SERVICE BULLETIN

Classification: RA04-001b	Reference: NTB04-065b	Date: November 9, 2005
------------------------------	--------------------------	---------------------------

2003 – 2005 350Z; CLICKING NOISE FROM REAR AXLES

APPLIED VEHICLE: 2003 – 2005 350Z (Z33) Coupe and Roadster

Figure 1

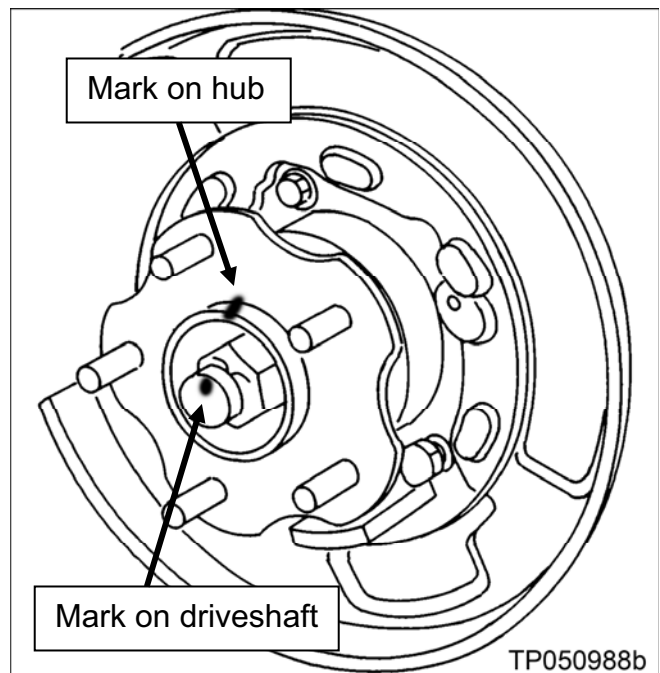
1. Determine if the noise is coming from one side or both sides.
 - If the noise is coming from **only** one side, perform procedure on **only** one side.
 - If the noise is coming from both sides, perform procedure on both sides.
2. Remove the rear axle (driveshaft).
 - Refer to section RAX in the Service Manual for the driveshaft removal information.
 - **IMPORTANT:** Make sure to mark the driveshaft and hub as shown in Figure 1 before removing the driveshaft.

Put a mark on the end of the driveshaft and a matching mark on the hub as shown in Figure 1.

NOTE: These marks will be used when reinstalling the driveshaft.
